MEMORANDUM

To: Harry Bronozian, MS; Chemical/Environmental Engineer
From: Ann Maest, PhD; Buka Environmental
Date: 27 August 2019
Re: Review of the ELARD/TRC Independent Third-Party Review of the Amulsar ESIA: Geology and Water Resources Sections

Figure 1. Operations phase water balance flow chart showing contact water planned to be used for dust suppression. Contact water ponds are shown in green outline. Contact water planned to be used for dust suppression without treatment is shown in the two pink highlighted areas (highlights added).

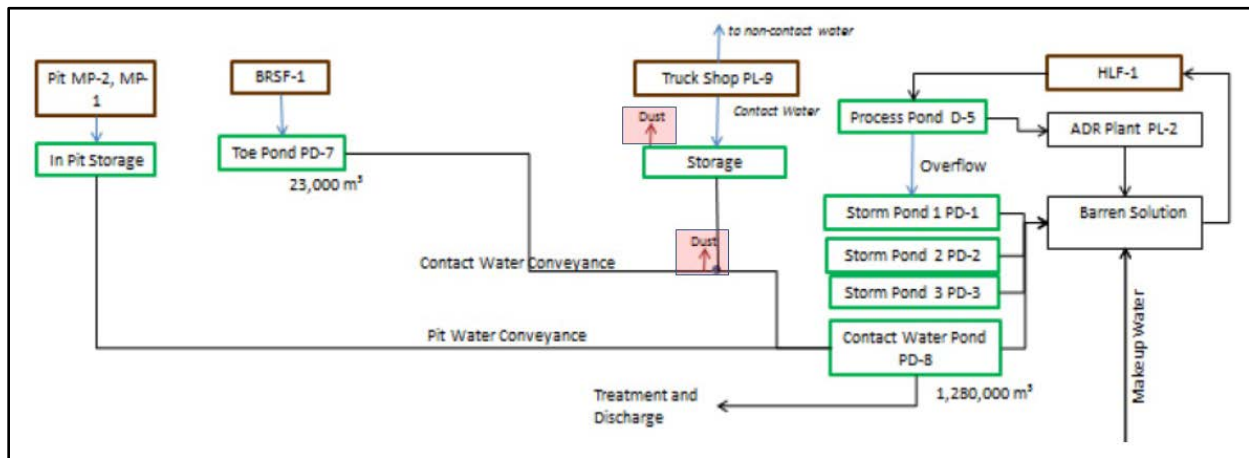
Lydian has committed “not to discharge any untreated contact water from the site to the environment” (Lydian Armenia CJSC, 2019). Contact water is water impacted by mining operations. Note that Lydian’s wording is “discharge” rather than release. The use of the word discharge by Lydian refers to contact water they have captured, whereas release refers to uncontrolled discharges. Regarding captured contact water, Lydian’s operational water balance flow chart shows that they plan to discharge untreated contact water for dust suppression (Figure 1). This constitutes a release of contact water to the environment and contravenes Prime Minister Pashinyan’s condition. If Lydian no longer intends to conduct this practice, they need to indicate how they will manage the water in a supplemental EISA.

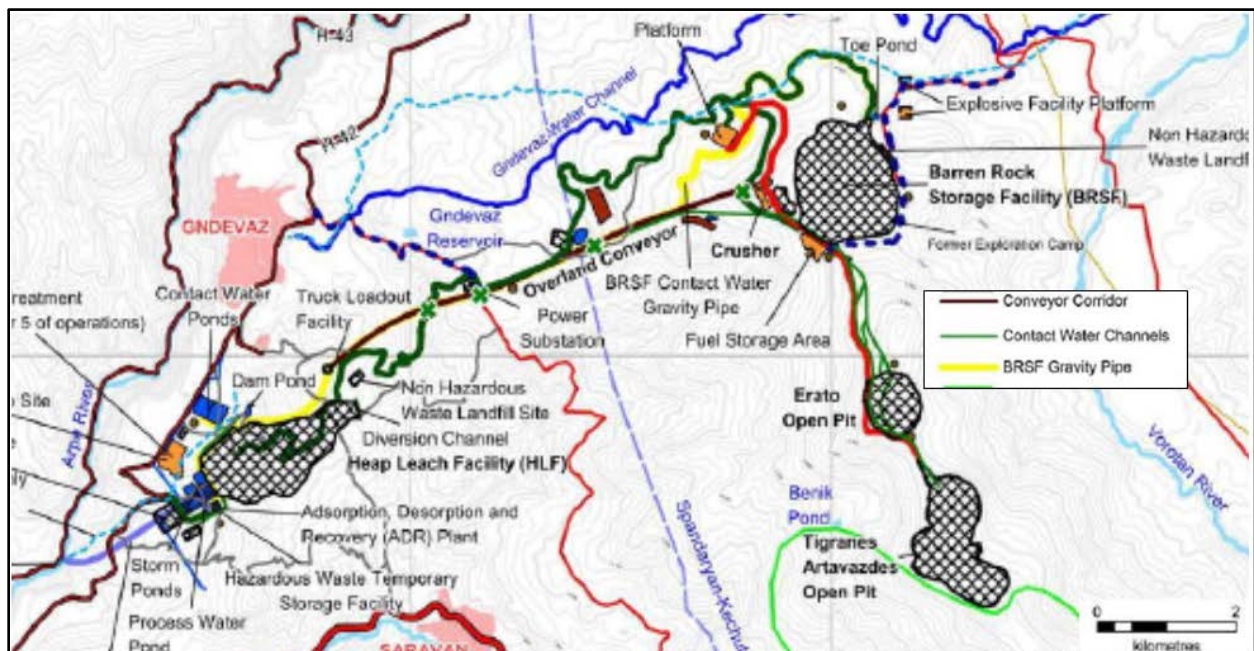
addition to unintended leaks and spills from the pits, the BRSF, and the HLF, Spills and leaks can occur from pipelines and other conveyances. As shown in Figure 2, many tens of kilometers of contact water pipelines and the crushed ore conveyer belt are planned for the Project; the potential for spills and leaks along these conveyances has not been assessed. Appendix 8.9 of the ESIA contains response plans, but the potential for impacts from the spills and leaks and the extent of the impacts has not been estimated. The severity of the impacts should be assessed quantitatively by conducting additional site characterization and prediction studies and specific studies that would simulate spills and leaks, to address Prime Minister Pashinyan’s condition that no contaminated water should enter the environment from the Amulsar Mine.

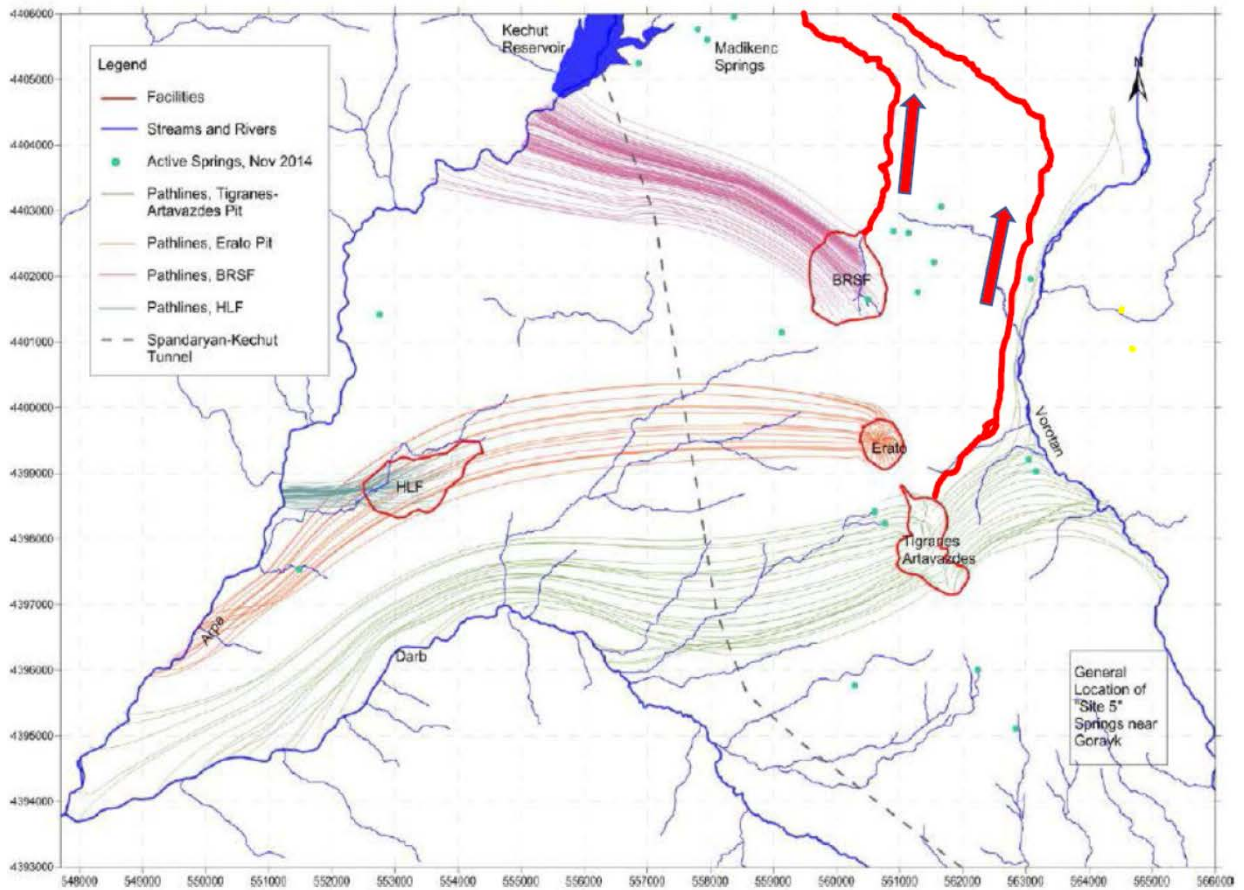
Both the Kechut Reservoir and the Spandaryan Reservoir are part of the National Water Supply system (ESIA, 2016. Table 6.10.3; Chapter 6.10). The Kechut Reservoir is hydrologically connected to Lake Sevan by the Spandaryan-Kechut Tunnel (Figure 3), and the mine pits and the BRSF (waste rock facility) lie within the immediate impact zone of Lake Sevan, which is protected by Armenian law (The Review, p. 35, 115). The BRSF and the tributary draining the BRSF (see Figure 3) are in the Kechut Reservoir drainage (see ESIA Fig. 6.10.1). Discharge at the Kechut Reservoir indicates that groundwater at the site is entering the Kechut-Spandaryan Tunnel (The Review, p. 34). Mine-influenced groundwater could flow into the tunnel and Lake Sevan if mitigation measures do not perform as expected. Groundwater pathways from the mine pit area to the Kechut-Spandaryan Tunnel are shown in Figure 4. Contaminants flowing to the Vorotan River will be transported to the Spandaryan Reservoir located to the south of the Amulsar Project on the Vorotan River.

One of the most important water quality concerns is uncaptured leachate from the BRSF. Predicted BRSF leachate concentrations during post-closure (Golder Associates, 2014a. Table 1) show high concentrations of nitrate (365 mg/L as N), zinc (2,300 µg/L), arsenic (105 µg/L), and selenium (52.8 mg/L), all of which exceed Armenian ARPA MAC standards by 2.6 to 146 times. High nitrate concentrations could contribute to eutrophication of the reservoir and Lake Sevan. Zinc is not adsorbed to the extent that other metals are, and it could potentially affect aquatic life in the Lake. Figure 3 shows groundwater flow paths leading from the BRSF directly to the Kechut Reservoir, but it does not show potential flow paths following the tributary on which the BRSF is located; the upper thicker red line shows this potential flow path. This tributary joins the Arpa River upstream of the Kechut Reservoir and will add contaminants to the upstream end of the reservoir if mitigation measures do not perform as planned. These contaminant inputs have not been considered as part of the water quality impact that could reach Lake Sevan.

Figure 4. Groundwater flow paths from the mine pit area to the Kechut-Spandaryan Tunnel and the Darb and Vorotan Rivers. The blue lines with arrows indicate groundwater flow directions and potential transport pathways for mine-related contaminants.

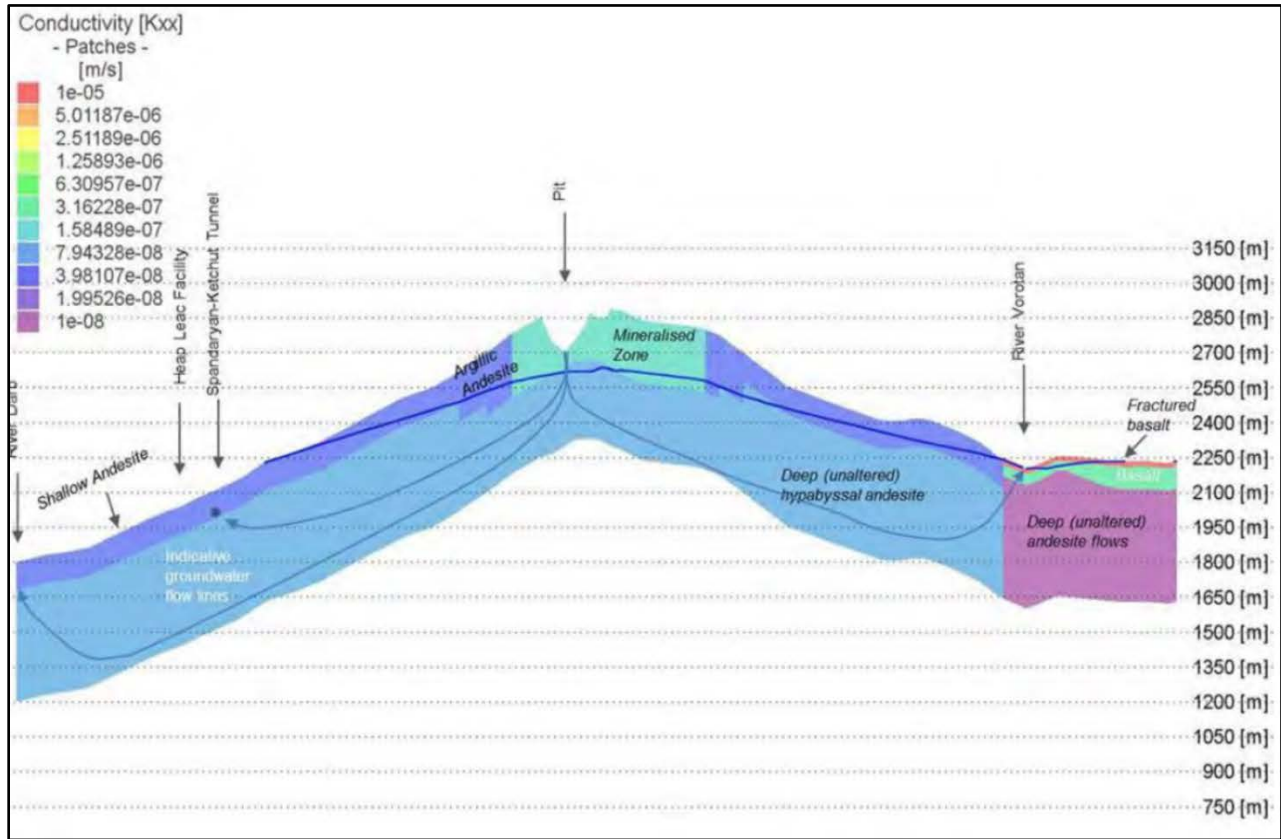
Agarakadzor fault could conduct contaminated groundwater to the Darb and Arpa Rivers. Similarly, the Zirak Fault could conduct contaminated groundwater, including potential seepage from the BRSF (elevation approximately 2,600 m), to the Kechut Reservoir (elevation approximately 1,950 m) and/or the Vorotan River (elevation approximately 2,200 m at the projected intersection of the Zirak Fault).
